RE: PROPOSED NEW RESIDENCE AT No. 7 LOVILLE AVE PEAKHURSTS

STRUCTURAL ASSESSMENT OF PROPOSED DA2021/0207

Image (A1) – 3D Computer Model input for structural assessment

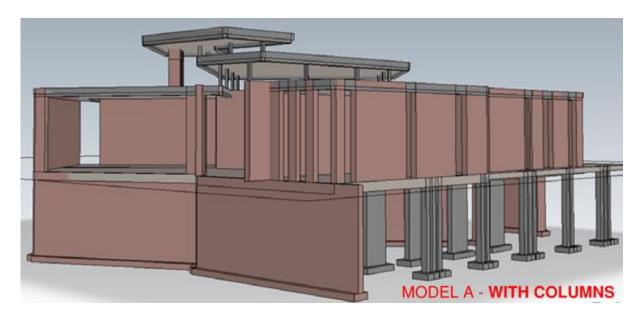
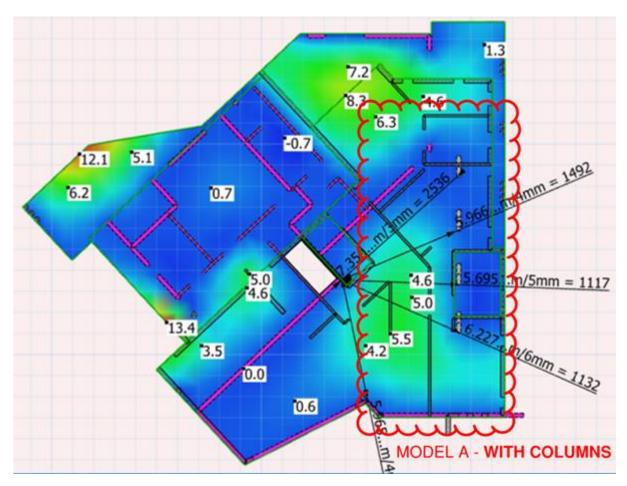
OPTION A involves the computer model with 4 blade columns, the number and size of the columns could be reduced slightly and the results would not alter significantly. The maximum deflection will be in the order of 5mm, complies with AS3600.

Four Blade Columns proposed alongside Southern end of secondary dwelling parking area.

Image (B1) – 3D Computer Model input for structural assessment

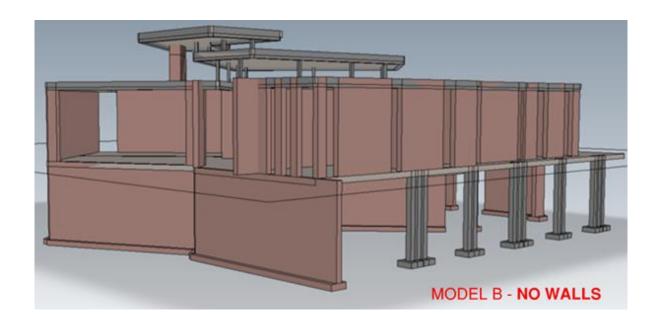
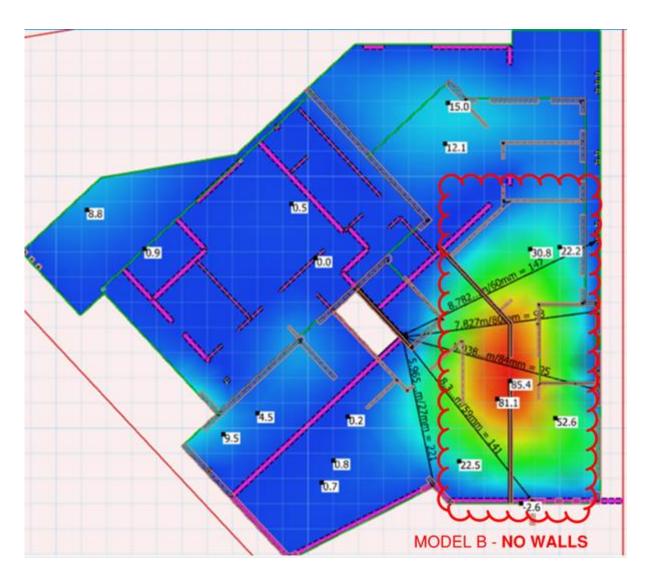
OPTION B is the same computer model with the 4 blade columns removed, the deflection of the slab has increased to 84.5 mm, which is excessive and does not comply with AS 3600

Complete removal of Southern wall adjoining the secondary dwelling parking area.

In light of the Finite Element analysis results, it is considered structurally necessary to have Some form of support along the line of the wall that is proposed to be deleted. If you have any further questions please do not hesitate to contact the under signed.
